SAN BERNARDINO COUNTY
DEPARTMENT OF PUBLIC WORKS
SPECIAL DISTRICTS

ADDENDUM NO. 1

CSA 70M WONDER VALLEY COMMUNITY CENTER KITCHEN AND RESTROOM REMODEL PROJECT

PROJECT NO.: 30.30.0149

DWG NO. 30.30.0149
SHEET NO. P-2.1
SHEET 1 OF

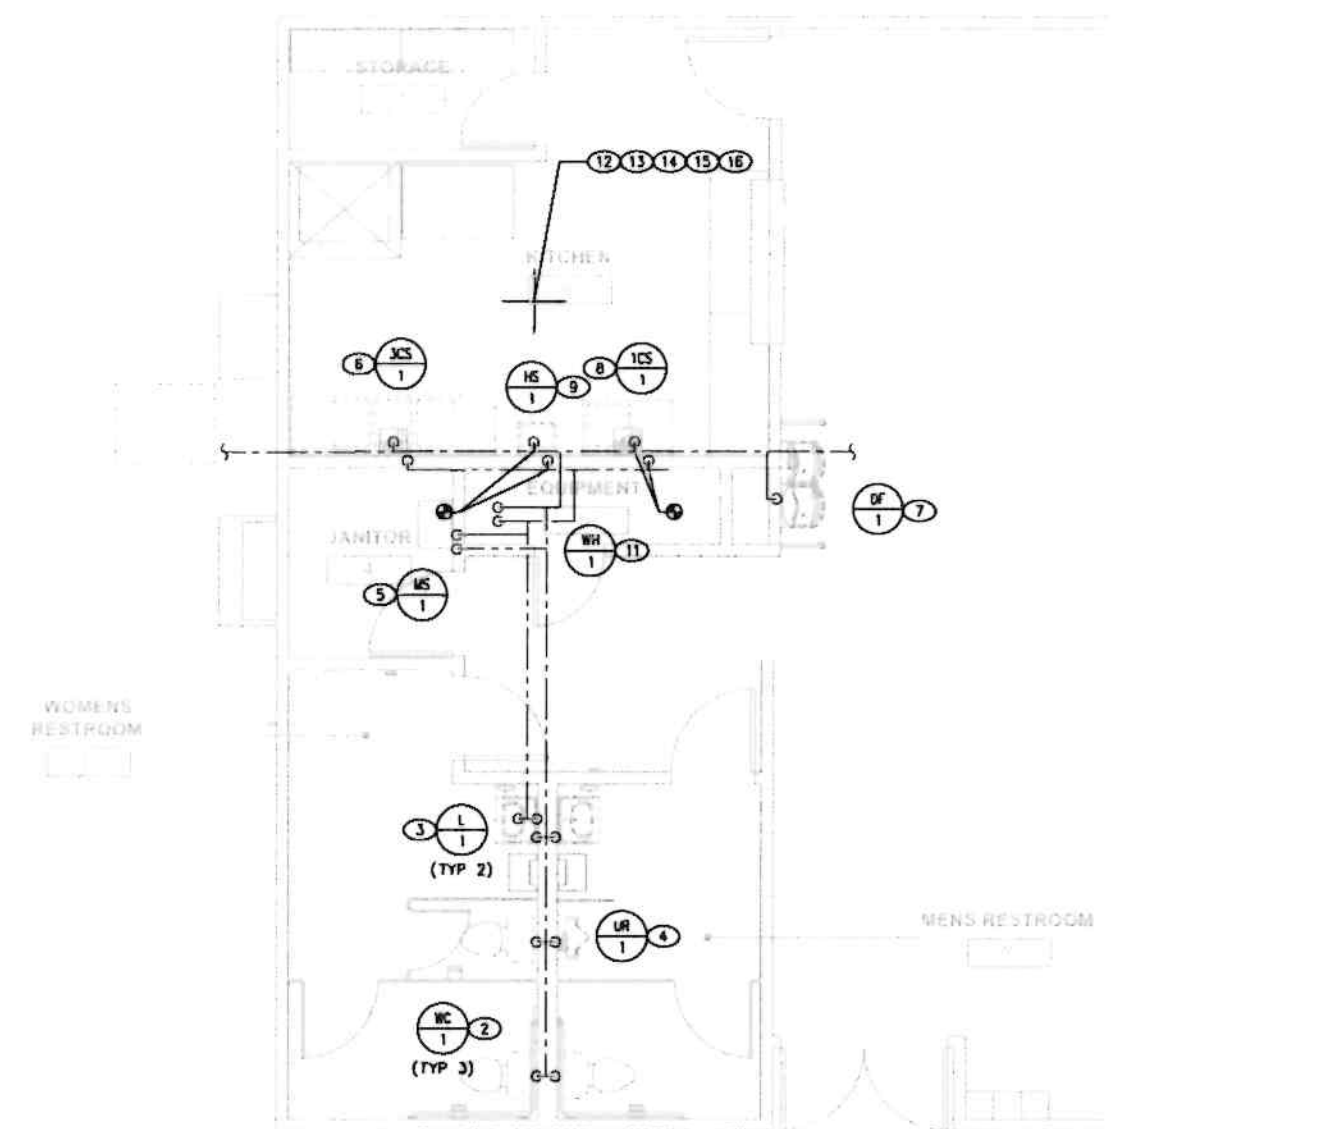
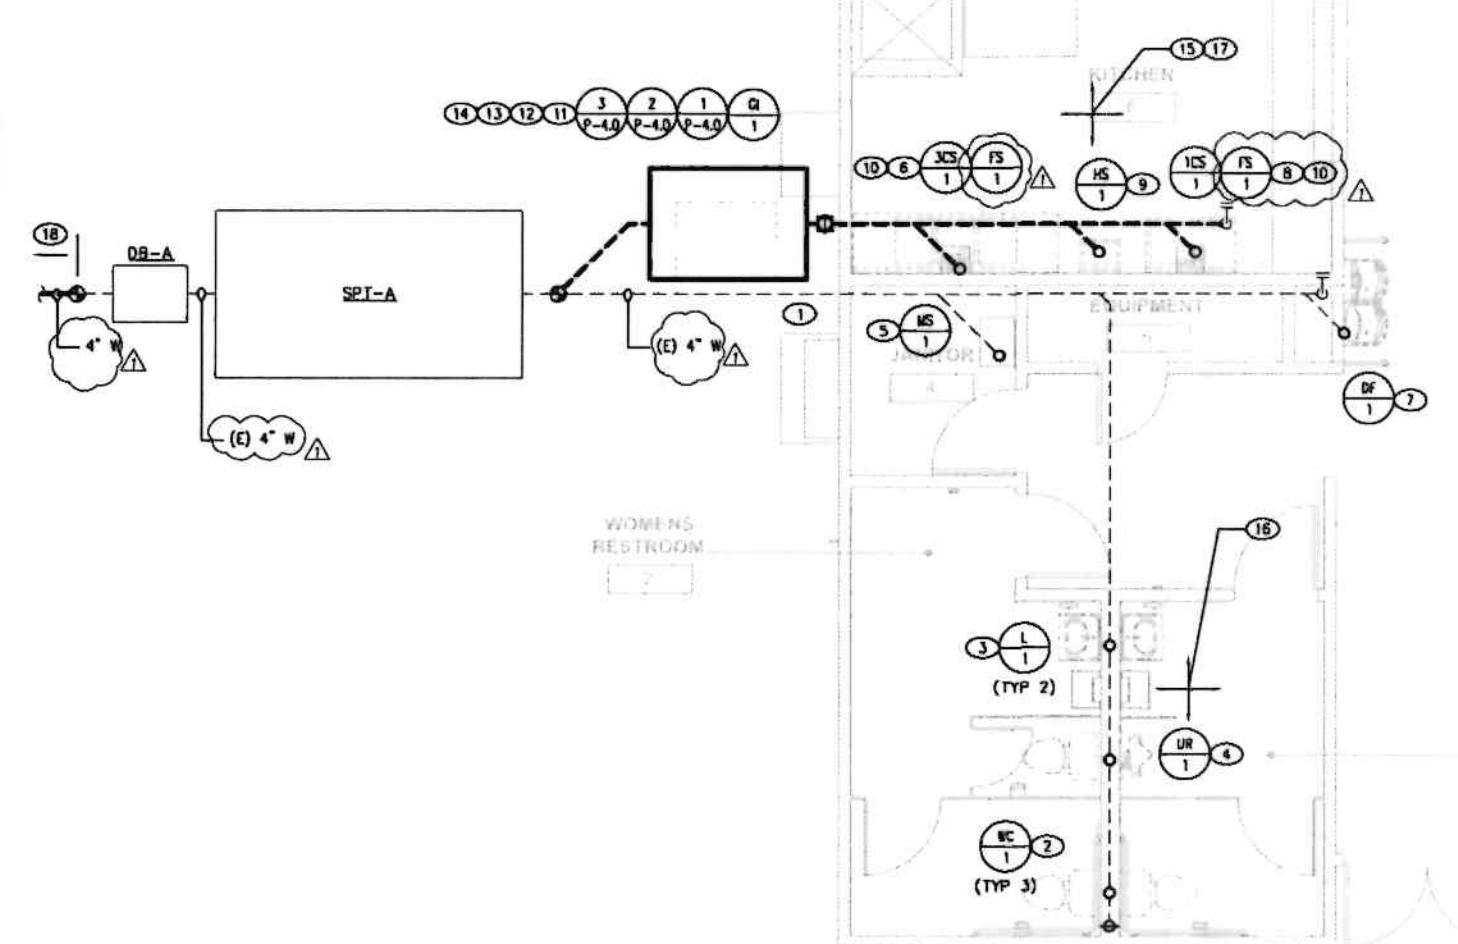
Question: 9. The Plans show the Mop sink is connected to the sanitary system and not the grease waste system. Please clarify.

Answer: That is correct, as shown on sheet P-2.1 the mop sink is connected to a waste line that goes directly to septic tank. Refer to the enclosed revised P-2.1 included in this addendum.
